CITY OF ST. PETERSBURG, FLORIDA  
PLANNING AND DEVELOPMENT SERVICES DEPARTMENT  
URBAN PLANNING AND HISTORIC PRESERVATION DIVISION

## STAFF REPORT

### Community Planning and Preservation Commission Certificate of Appropriateness Request

CITY FILE NO.: 20-90200053

**2 PROPOSED REAR ELEVATION**  
 D4 1/4" = 1'-0"

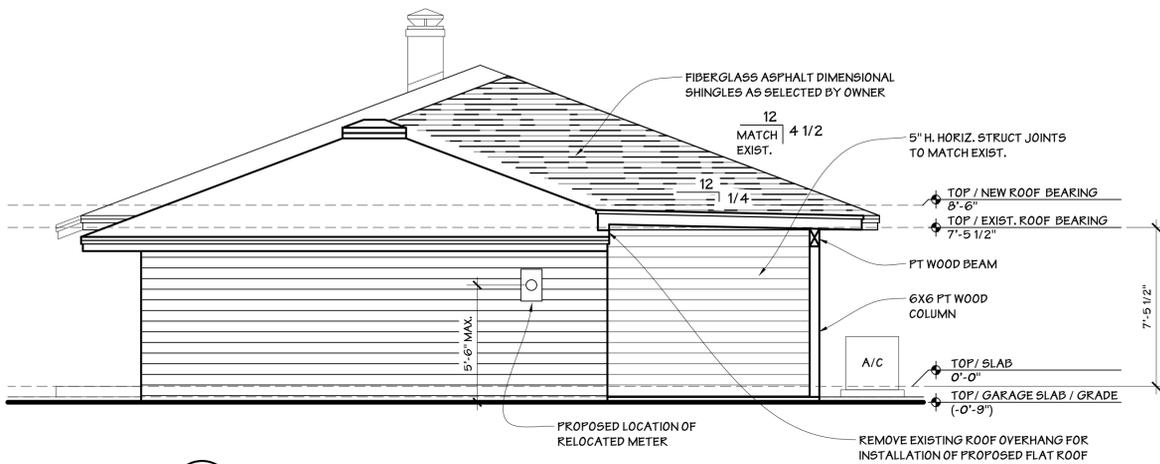
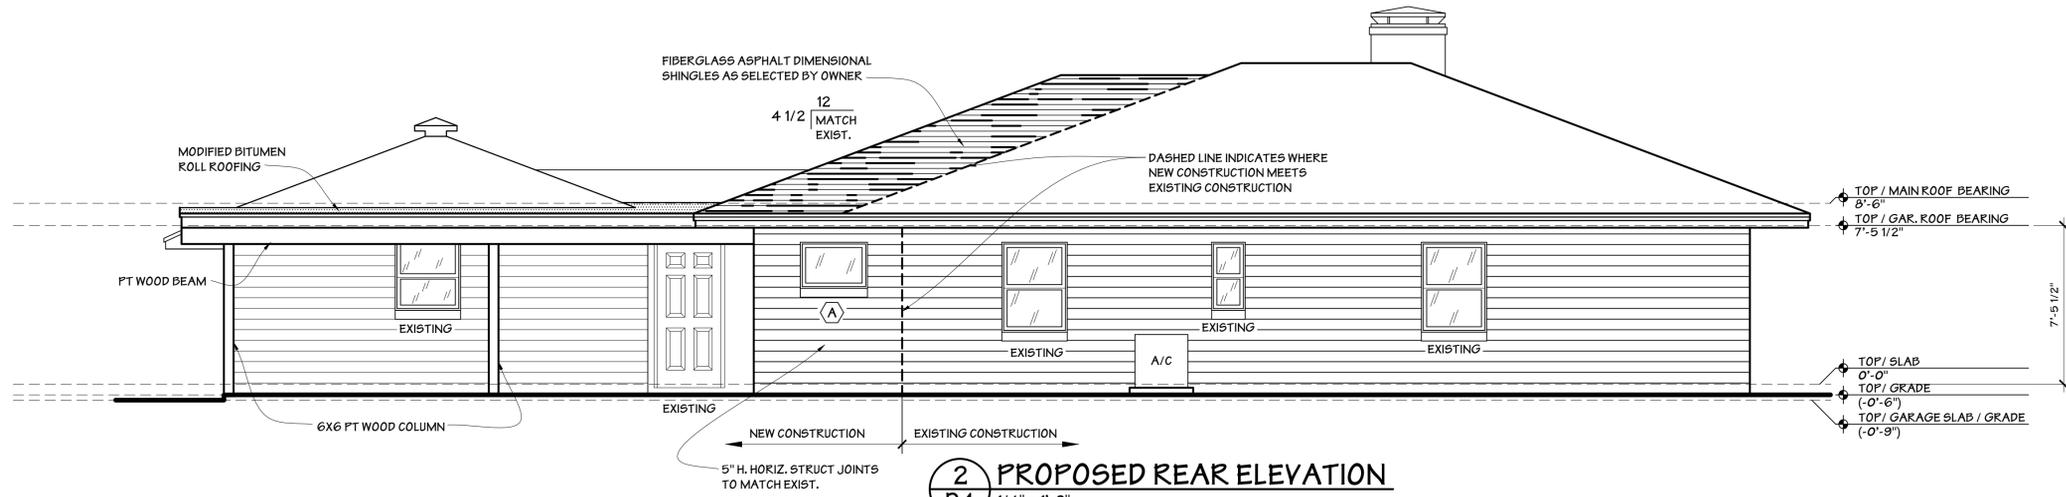
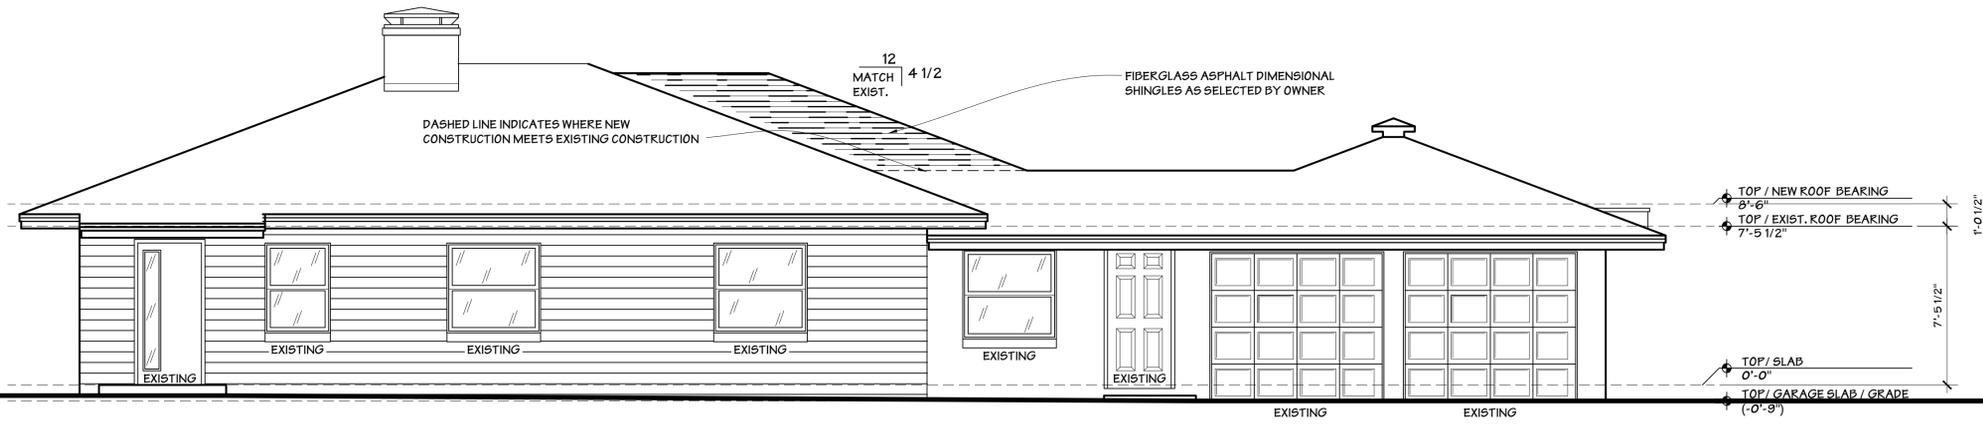
**Consistent** The 7' addition will elongate the building slightly when viewed from the east (rear) elevation. This is compatible with other transitional and mid-century Masonry Vernacular buildings in the proposed district, as is the low profile of the flat-roofed rear porch structure.

**Consistent** The addition's footprint will not be visible from the front elevation. The extended roofline will be slightly visible above the semi-detached garage but will match the existing pitch and therefore be compatible.

**Consistent** The addition will extend the enclosed mass of the residence by 7' at the east elevation, its greatest impact. The full width of the residence will continue to be visually broken up by the flat porch roof and the semi-detached garage, which will still be articulated by a break in the wall plane, a setback, and a distinct roof shape.

**Consistent** The proposed porch features a flat roof and will appear to be recessed within the existing shape of the building footprint. This is consistent with nearby mid-century resources, which often feature porches with flat roofs or recessed into building corners.

**Consistent** The proposed roof of the enclosed space will match the pitch of the existing roof, which is typical of similar resources. The flat roof of the porch is an appropriate way to add covered space without creating a roof structure that is unnecessarily complex.

1. Windows will be installed to be setback within the wall plane and feature a reveal of at approximately two to three inches to provide consistency with existing windows at subject property.
2. All other necessary permits shall be obtained. Any additional work shall be presented to staff for determination of the necessity of additional COA approval.
3. This approval will be valid for 24 months beginning on the date of revocation of the local Emergency Declaration.
